CHANGE ORDER NO. 2

OWNER	City of Baxter	DATE	June 24, 2024
CONTRACTOR	RL Larson Excavating, Inc.	SEH No.	BAXTE 172114
ENGINEER	SEH	City No.	4138
Project	2024 South Forestview Area Improvements, Baxter

STREET PLAN & PROFILE

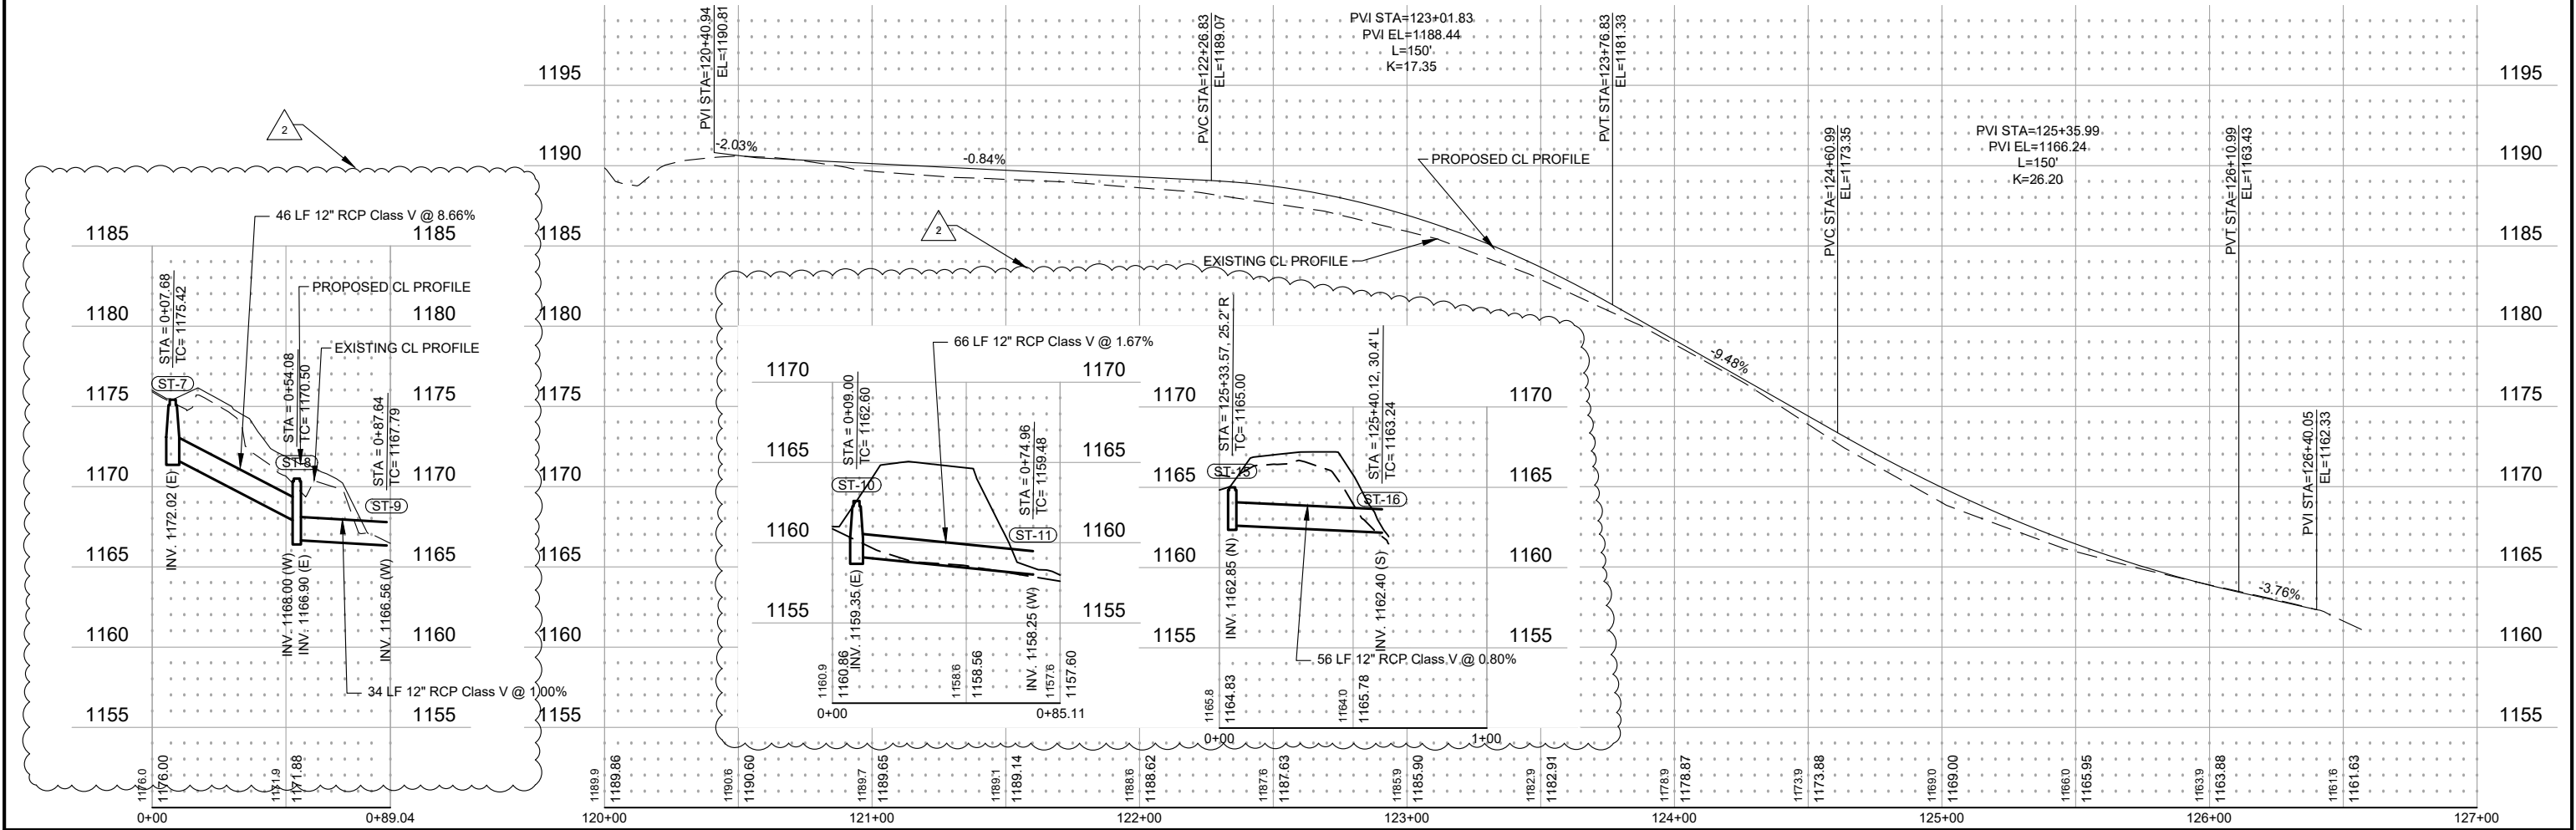
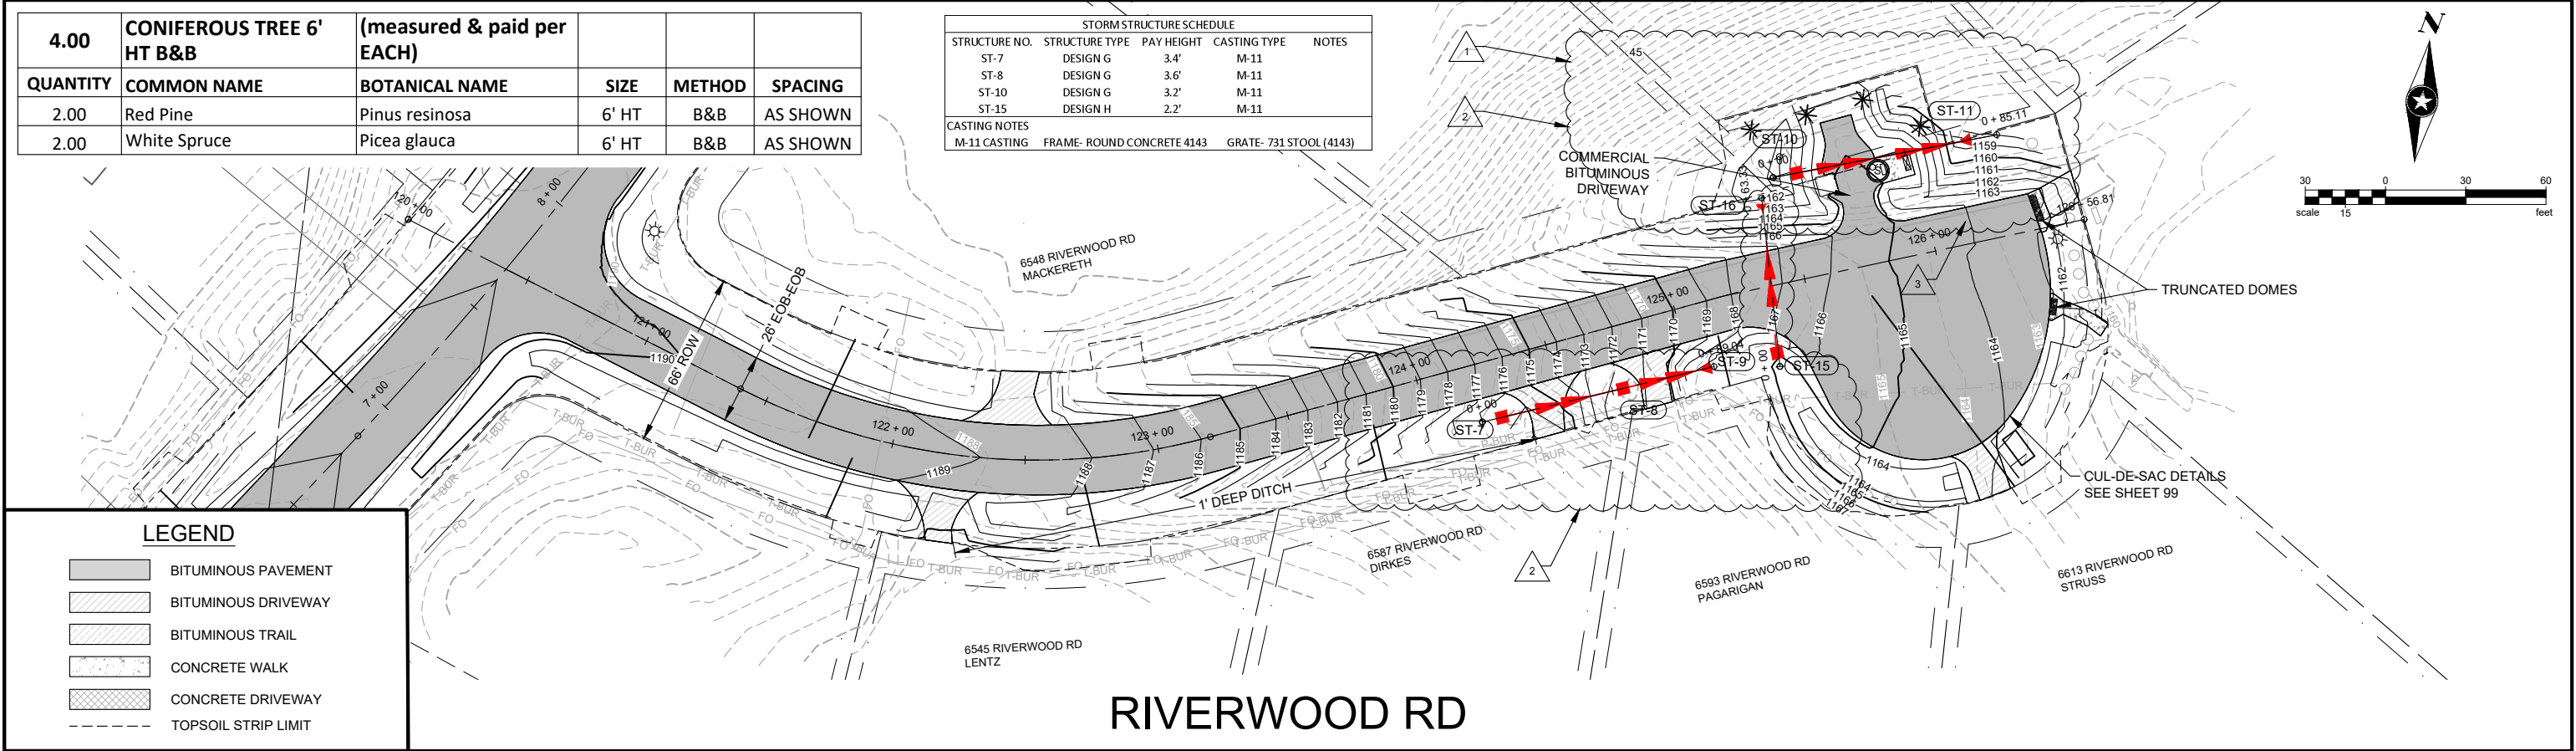
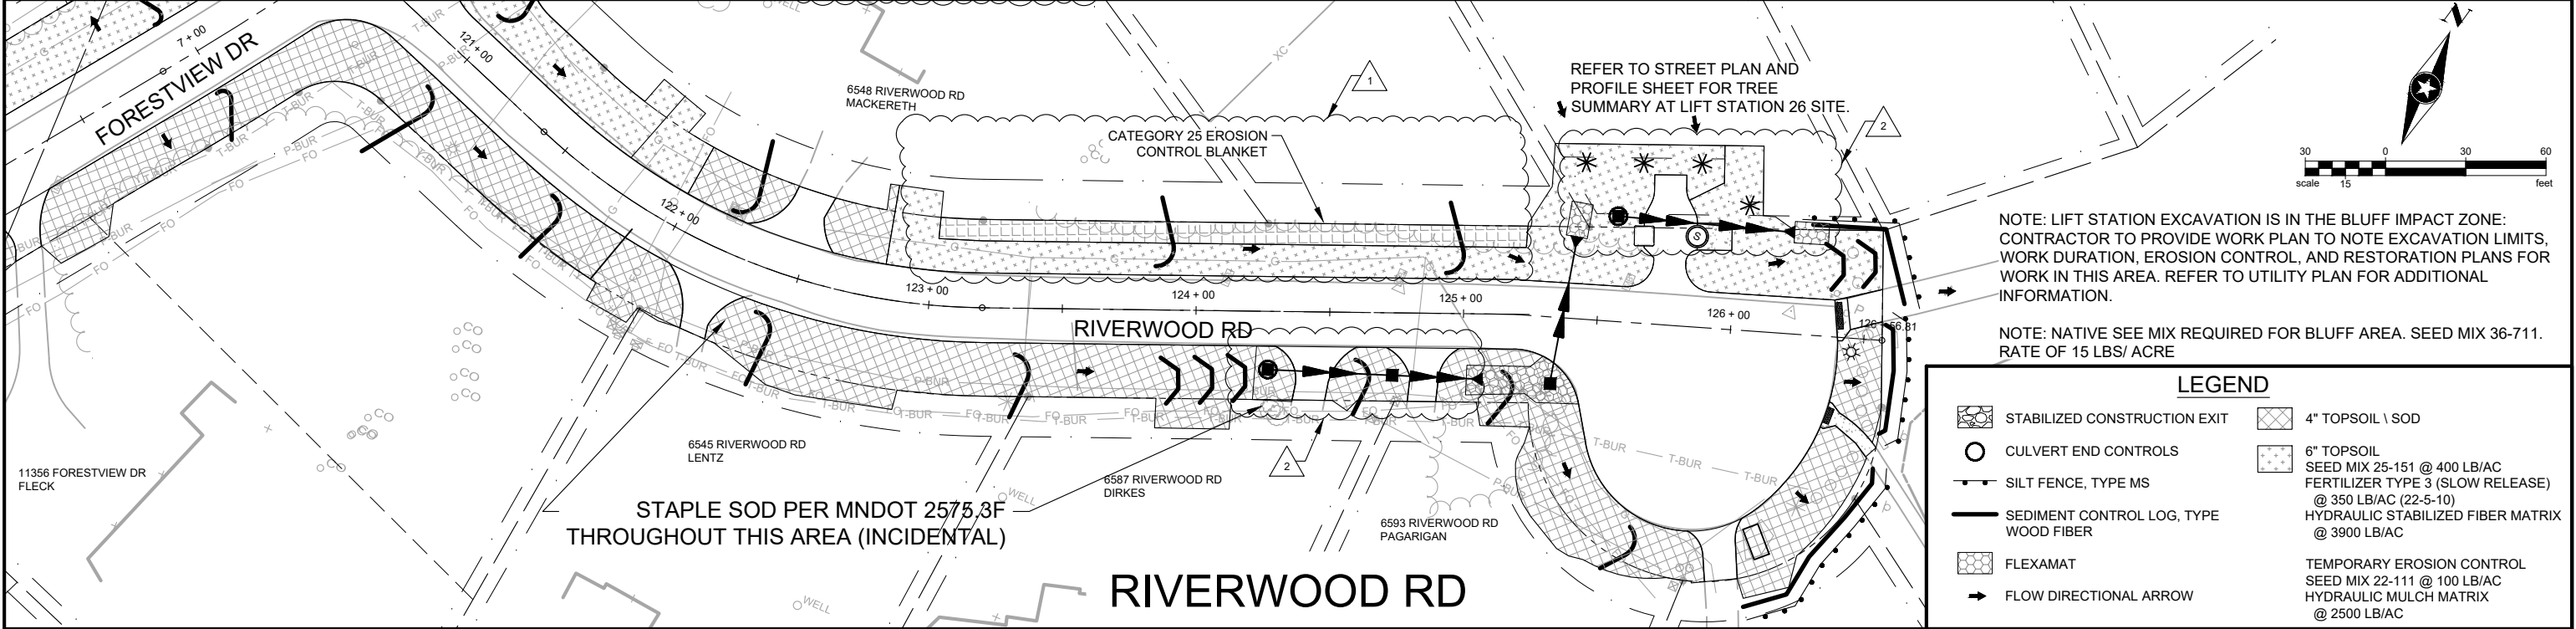
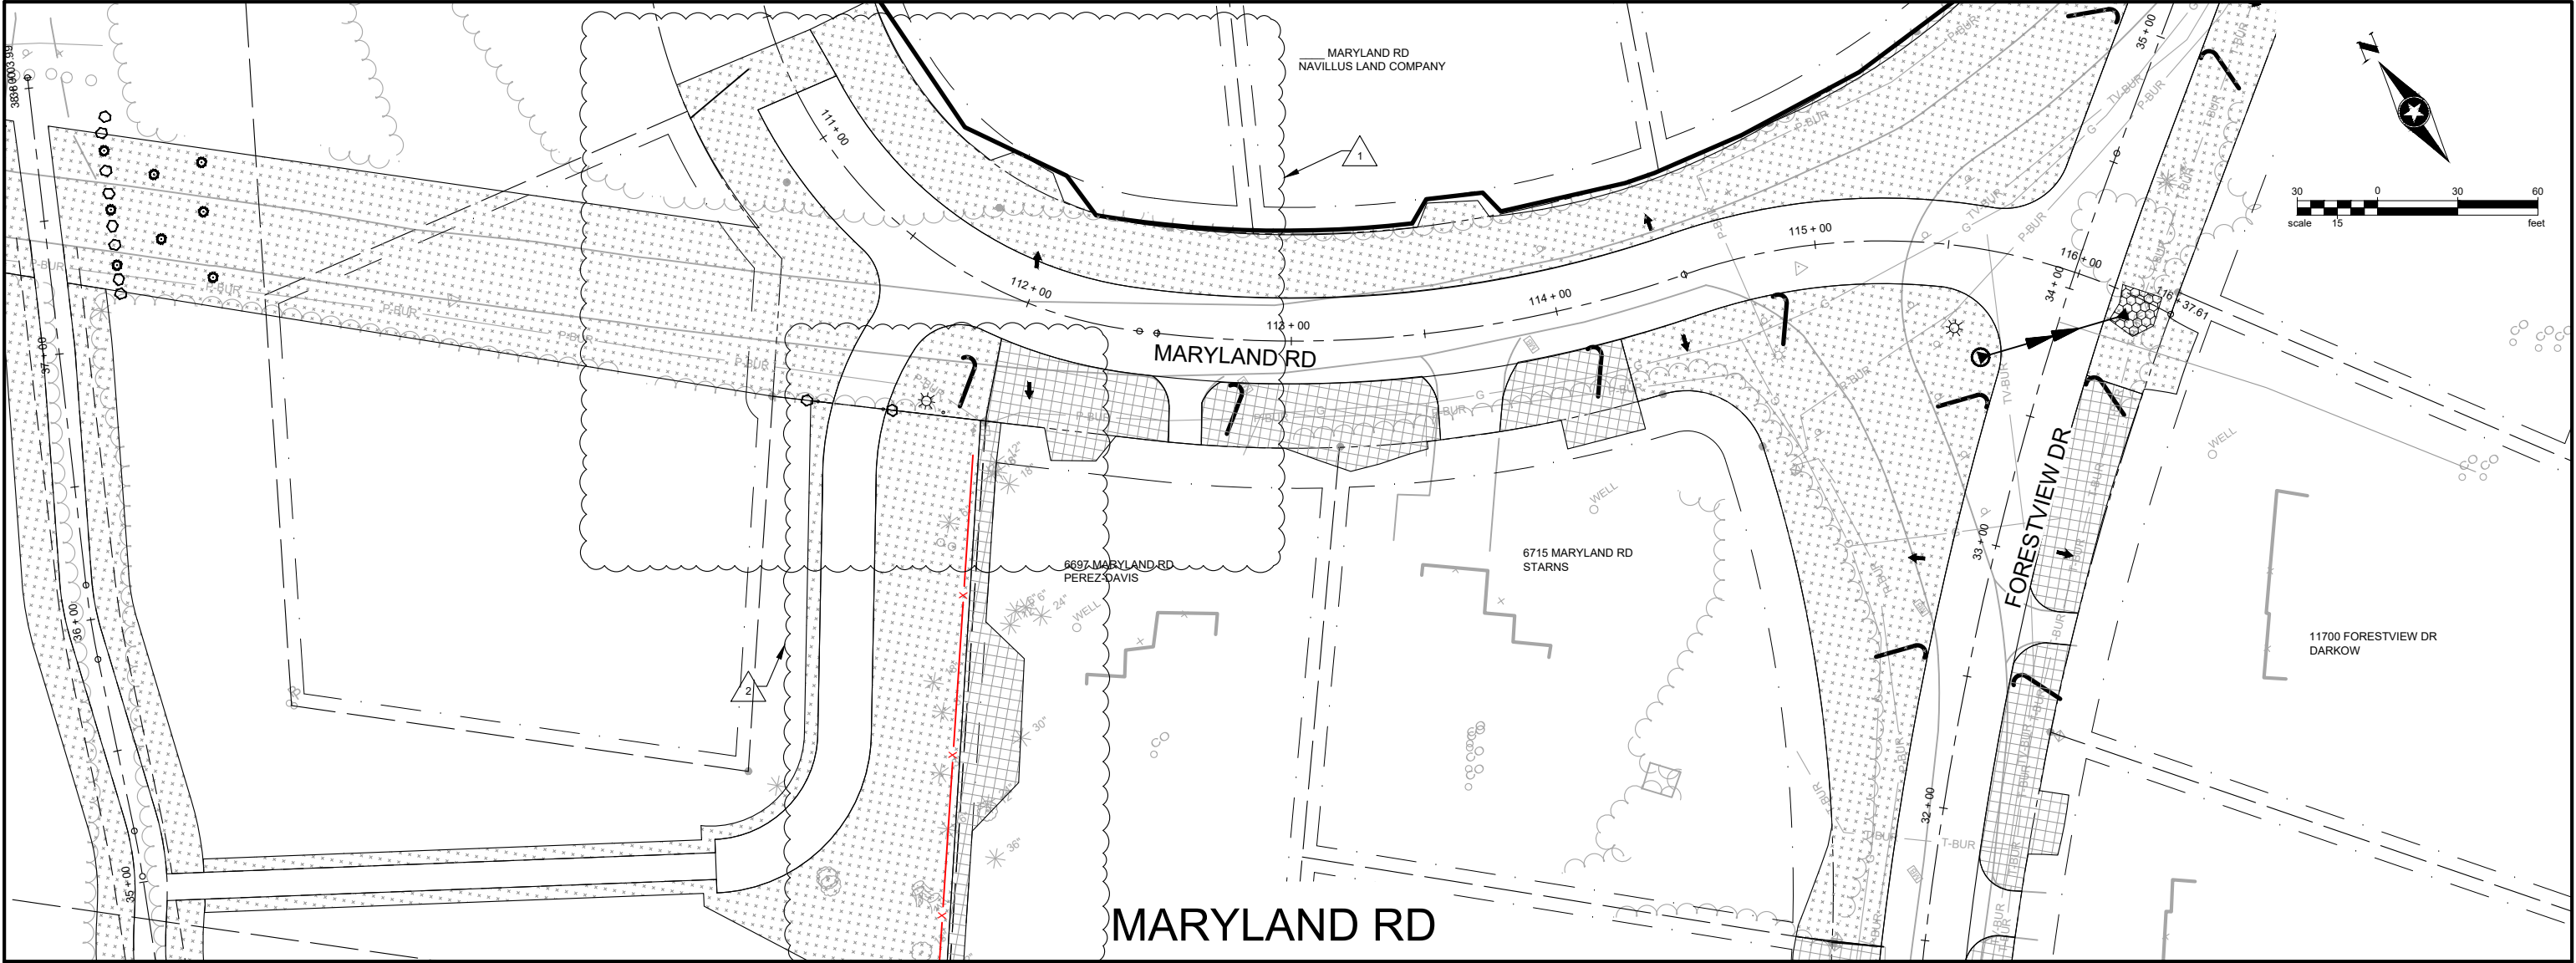
Storm sewer and layout of erosion control measures were modified along Riverwood Road from the initial design. After review by the Engineer and Owner, inlets and storm sewer piping were utilized near driveways to collect and manage stormwater runoff. In addition, the use of flexamat was reduced in the ditches per request of an adjacent property owner. In addition, a storm sewer crossing was discovered during construction that was not identified in the City's overall storm sewer map. This storm crossing is proposed to be installed to return drainage patterns to pre-existing conditions. Plans were updated for this street, and new item were added to the contract to account for this change. Plan sheets are attached for reference.
